LINCOLN CITY/LANCASTER COUNTY PLANNING STAFF REPORT

for June 22, 2004 PLANNING COMMISSION MEETING

PROJECT #: Preliminary Plat #05009
West Hobelman Addition

PROPOSAL: Preliminary plat 8 commercial and industrial lots.

**WEST HOBELMAN ADDITION
PRELIMINARY PLAT
LINCOLN, NEBRASKA**

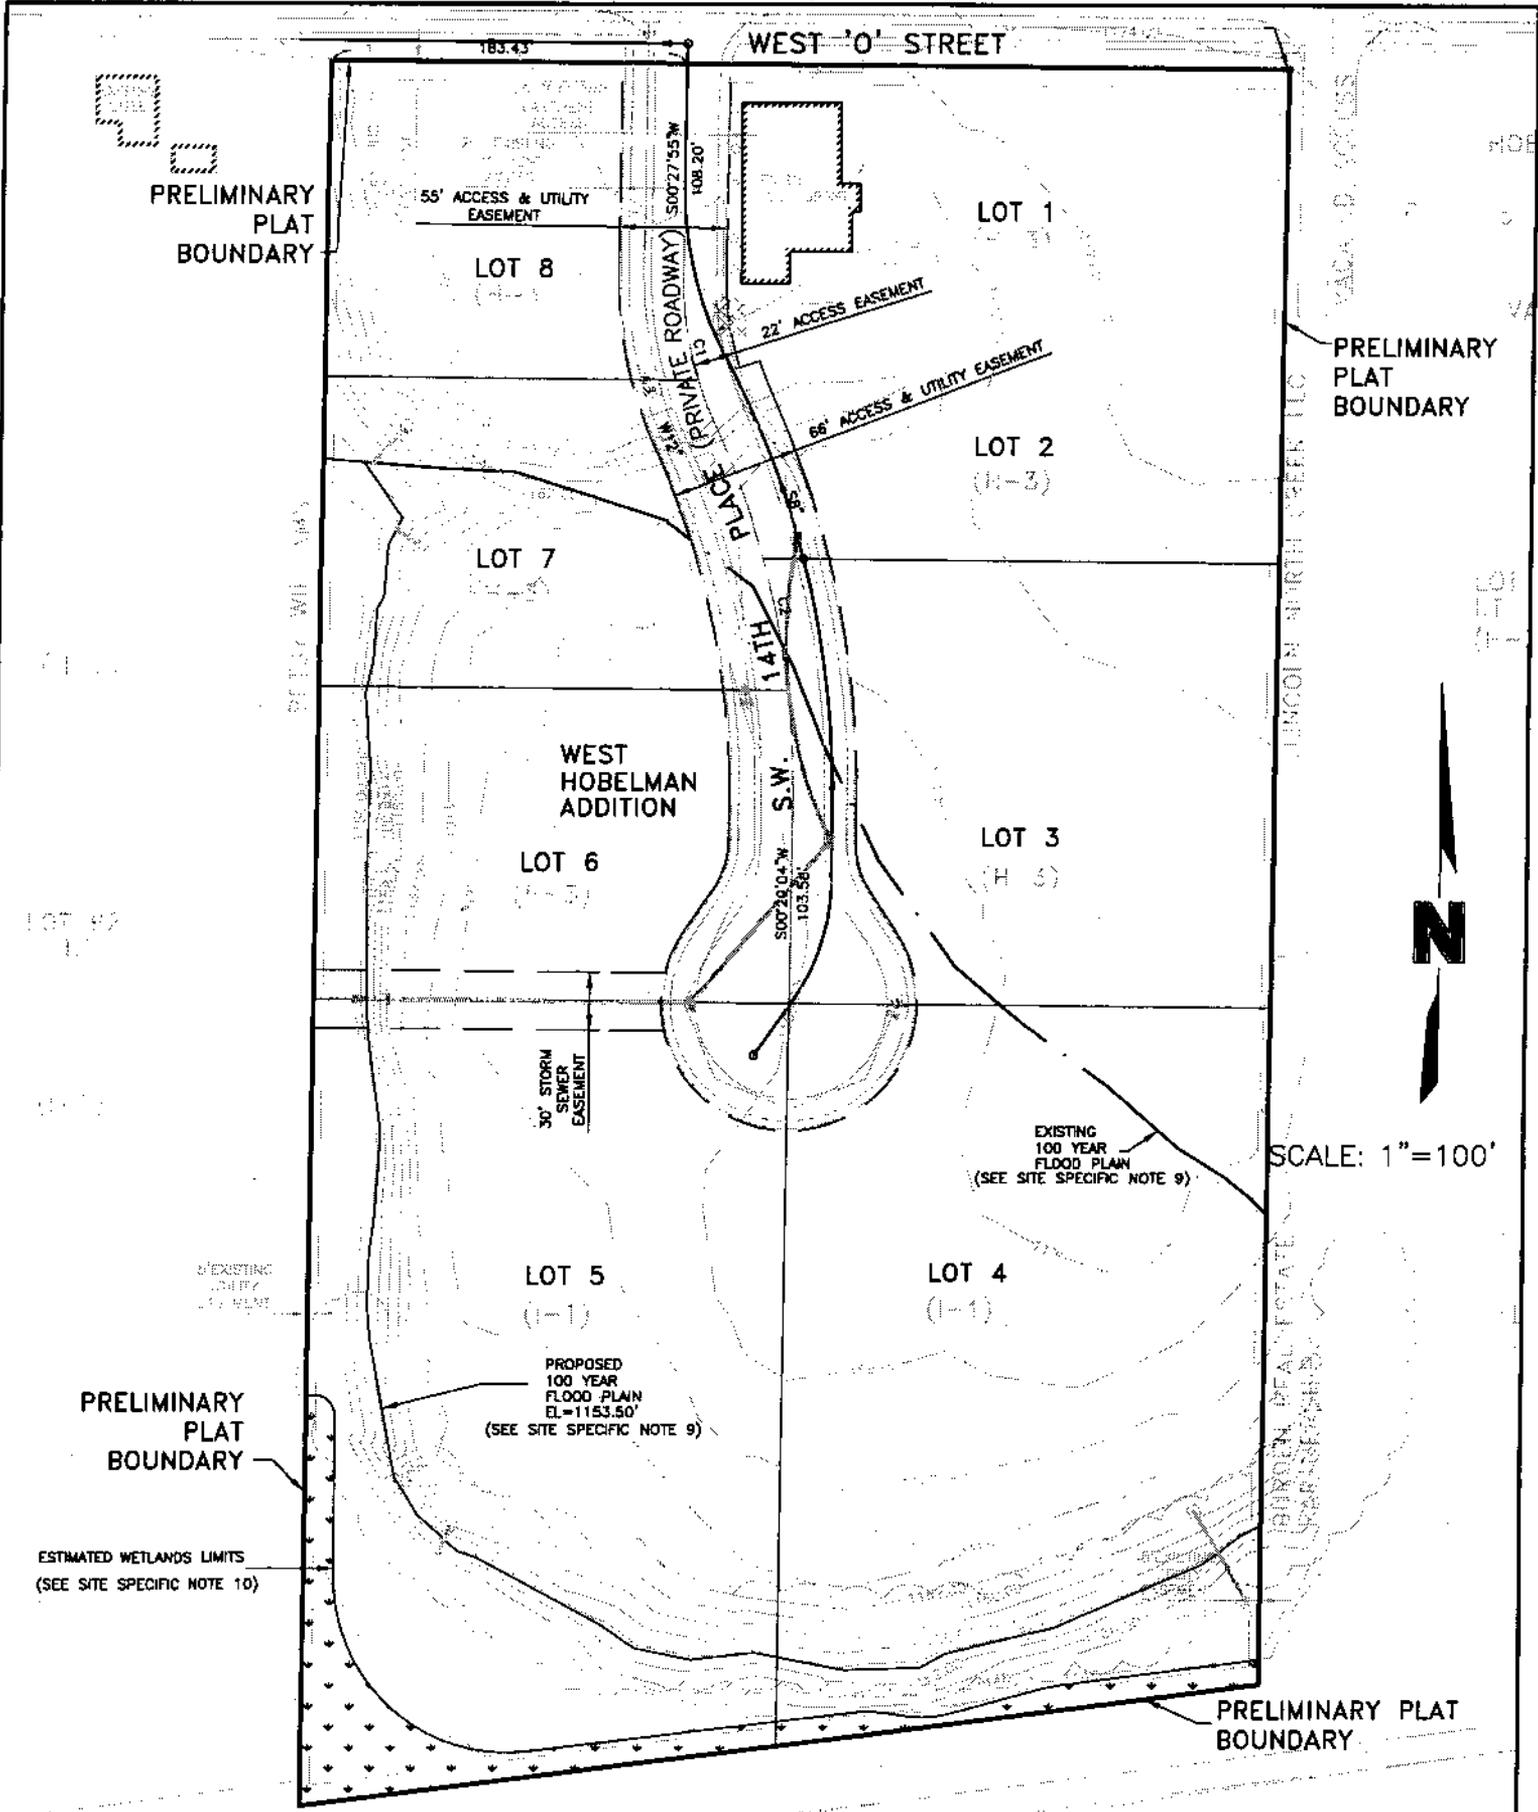
1. This is a request to preliminary plat 9.79 acres into 8 lots. This property is currently zoned H-3 and I-1.
2. West "O" Street has a center turn lane, which provides full access to this site at SW 14th Place; additional access to West "O" Street has been relinquished and the existing driveway should be removed. At present, there is no median across this frontage. Although none are planned at this time, future improvements to West "O" Street may result in limitations on access at SW 14th Place.

3. The development of this property should provide access to adjoining properties on the east and west in order to facilitate the future development of those parcels and provide east/west circulation. The nearest traffic signal is located at West "O" and Capitol Beach Boulevard, approximately 380' east of this property.

4. Applicant proposes to waive the requirement that the street and alley layout provide access to adjoining properties. Instead, they propose to provide access to the east through a public access easement to be identified at the time of building permits. Providing access through a public easement is acceptable provided its location is shown on the drawings at this time rather than at the time of building permits. Should Applicant need to move the access easement at a later date, a note can be added

5. Applicant proposes to provide no access to the west, due to existing wetlands proposed to be used for stormwater detention. However, there is developable land at the north end of this parcel that would benefit from access across this development and to the traffic signal at Capitol Beach Boulevard and West "O" Street. Applicant should provide access to the west in a manner similar to their proposal for access to the east.
6. City Department comments:

- 6.1 The requested waiver of design standards to construct sanitary sewer opposite street grade is satisfactory to Public Works. However, it does not appear that the requested waiver of design standards to construct sanitary sewer in excess of 15' is required. The plans show the sewer being constructed at a grade more than the minimum slope. If the plans are revised to show the sewer constructed at minimum grade the depth waiver is not necessary.

- 6.2 As discussed in meetings with the applicant, due to the proximity to existing structures, the waiver to construct sanitary sewer on the east side of the street and water main on the west is acceptable to Public Works.

- 6.3 Public Works approves the use of public access easements instead of requiring public or private street to provide access to adjoining properties. However, Public Works does not agree with approving the public access easements at the time of building permits. A public access easement needs to be shown to the east and the west properties with a note generally stating that the locations of the public access easements may change with the approval of a final plat.

- 6.4 Public Works does not agree with waiving the requirement to provide access to the property to the west. Approximately the north 200' of this lot is clear of wetlands and could be developed with a fill permit. Providing this public access could eventually give this property access to the traffic signal at Capital Beach Boulevard and West "O" Street.

- 6.5 Public Works does not approve the requested waiver of design standards for storm water detention. G & C Addition and EDM Industrial Park have recently been approved in the vicinity of this project and both required detention. There does not appear to be any justification for waiving the detention requirement.

- 6.6 If detention is intended to be provided on the adjacent property to the west, a dedicated easement agreement along with supporting detention calculations will have to be provided to the satisfaction of Public Works prior to this project going to City Council. Also, if the proposed detention is to be located in the area of the wetlands written documentation of approval from the Army Corps of Engineers will need to be provided prior to City Council. If either the aforementioned easement

agreement or the Corps approval is not obtained, the grading and drainage plan will need to be revised to show on-site detention in accordance with City of Lincoln Design Standards and the Drainage Criteria Manual.

- 1. Complete the following instructions and submit revised documents and plans along with 6 copies to the Planning Department office. Once approved, the preliminary plat will be signed by the Chair of the Planning Commission certifying approval. These documents and plans are required by ordinance or design standards.
 - 1.1 Revise the preliminary plat as follows:
 - 1.1.1 Show a paved public access easement providing access to the adjoining parcels to the east and west. Add a note indicating the location of the public access easement shall be shown on and may be changed with a final plat.

- 1.1.2 Complete revisions and provide documentation as requested in Analysis paragraph 6, to the satisfaction of the Public Works and Parks and Recreation Departments.
- 1.1.3 Add as note indicating street trees will be shown with final plats.
- 1.1.4 Show required LES easements.
- 1.1.5 List all waivers that are granted.
- 1.1.6 Show sanitary sewer constructed at minimum grade and less than 15 feet below grade, unless the waiver request is approved by City Council.
